UCID- 18691

TECHNICAL EVALUATION OF THE PROPOSED DESIGN  
MODIFICATIONS AND TECHNICAL SPECIFICATION  
CHANGES FOR THE R. E. GINNA NUCLEAR POWER PLANT,  
UNIT 1

TECHNICAL EVALUATION REPORT  
PROPOSED DESIGN MODIFICATIONS  
AND TECHNICAL SPECIFICATIONS  
ON GRID VOLTAGE DEGRADATION  
FOR THE  
R. E. GINNA NUCLEAR POWER PLANT  
UNIT 1

(Docket No. 50-244)

Figure 1. Loss-of-voltage and second-level undervoltage relay operating ranges.

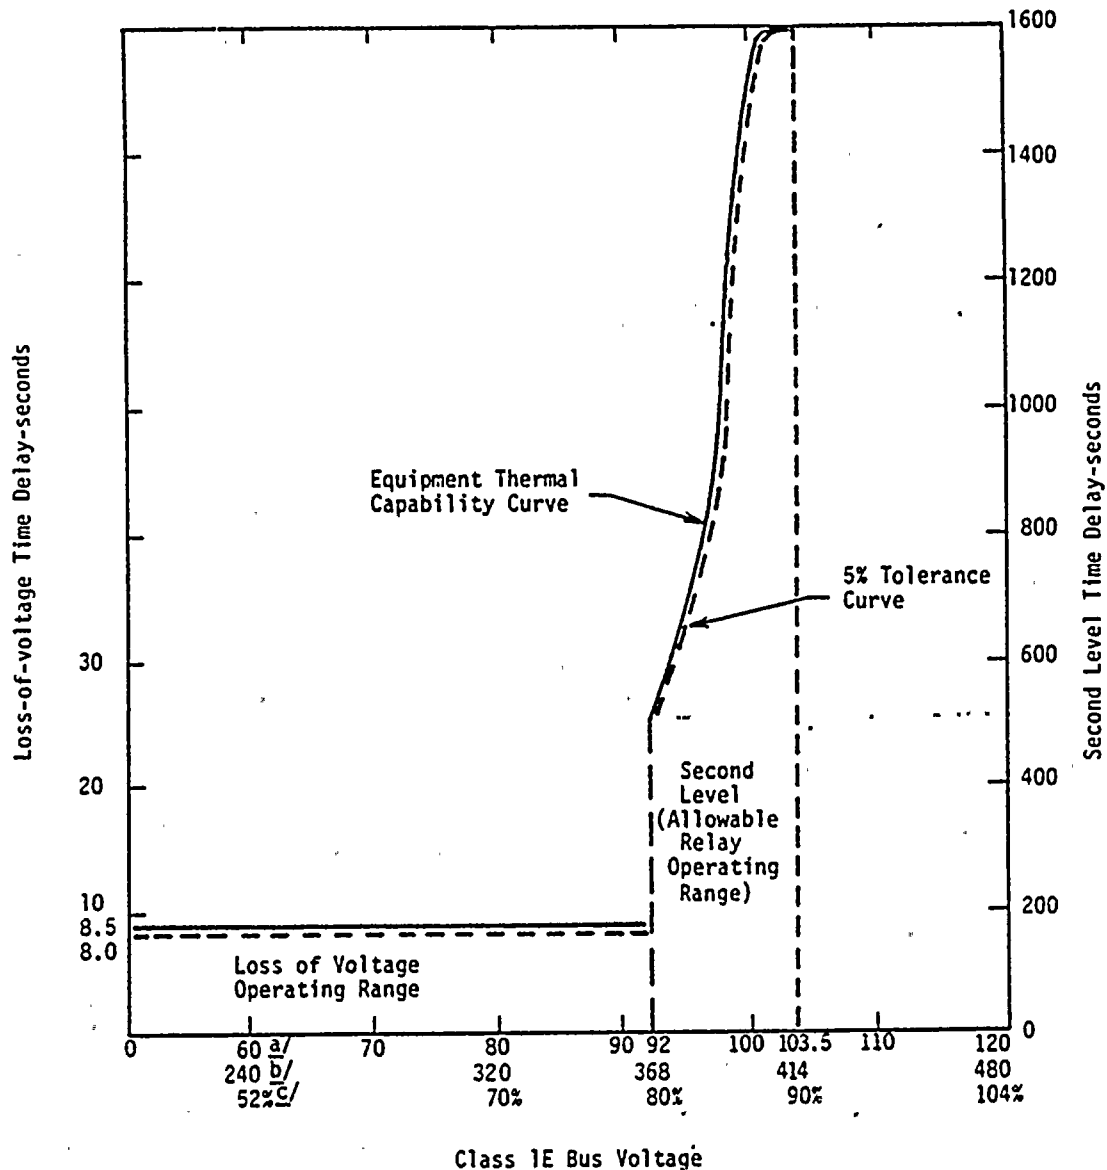
The licensee's second level of undervoltage protection setpoints (voltage and time delay) are defined by the curves shown in Figure 1. The solid-line curve defines the maximum time (determined by equipment manufacturers) that the Class 1E equipment can operate for a specific degraded voltage without causing equipment damage, loss of equipment life, or affecting the ability of the equipment to perform a required function. The maximum time delay at the 414-volt setpoint is 1600 seconds. The dotted-line curve (5% tolerance band) defines the maximum allowable time delay before protective relaying actuation is initiated. This tolerance band was determined by all the accuracies of the relay test instrumentation. The relays will be tested to insure that they perform according to their design operating characteristics, which must fall within the area defined by the dotted-line curve in Figure 1.

Any deviation outside the limits defined in Figure 1 will result in recalibration of the relay. The licensee's analysis has been reviewed and shows that this protection range is satisfactory for the 480-volt Class 1E loads and other components whose functional performance would be inadequate because of undervoltage.

The second-level undervoltage relay setpoints defined in Figure 1 are such that the relay operating characteristics will protect the Class 1E equipment from sustained degraded voltage and also insure that all Class 1E motors will start successfully and be loaded onto the diesel generator within the time assumed in the FSAR accident analysis.

The licensee's proposed time delay defined in Figure 1 is long enough to override any short grid disturbances.

Figure 2. Coincident trip logic for bus 14.

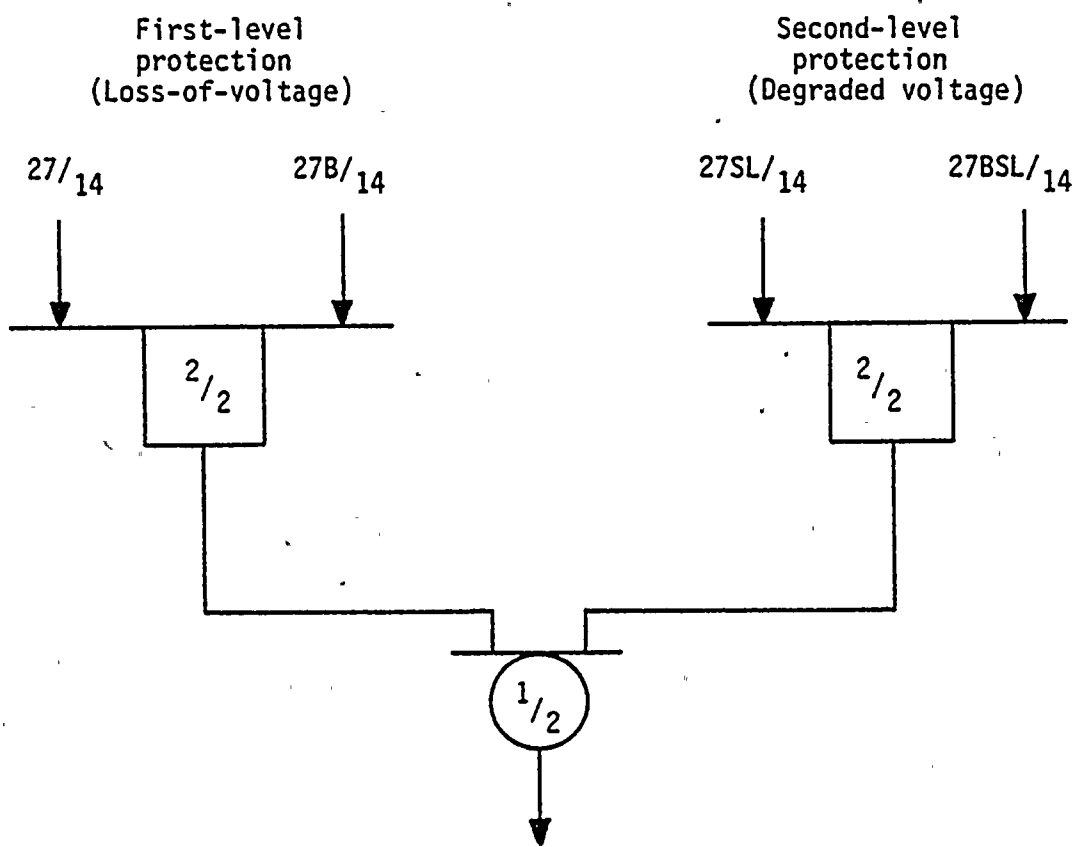
The second-level protection scheme will be designed using two-out-of-two coincident logic. The integration of the second-level protection system into the first level of undervoltage protection can be seen in Figure 2. If a loss-of-voltage condition exists, relays 27 and 27B will drop out and initiate the automatic voltage-restoring scheme. For a degraded voltage condition, relays 27SL and 27BSL will drop out after the time-delay setpoints are exceeded and will initiate the automatic voltage-restoring scheme.

The two-out-of-two coincidence logic automatically disconnects offsite power from the Class 1E buses experiencing degraded voltage and initiates the voltage-restoring scheme.
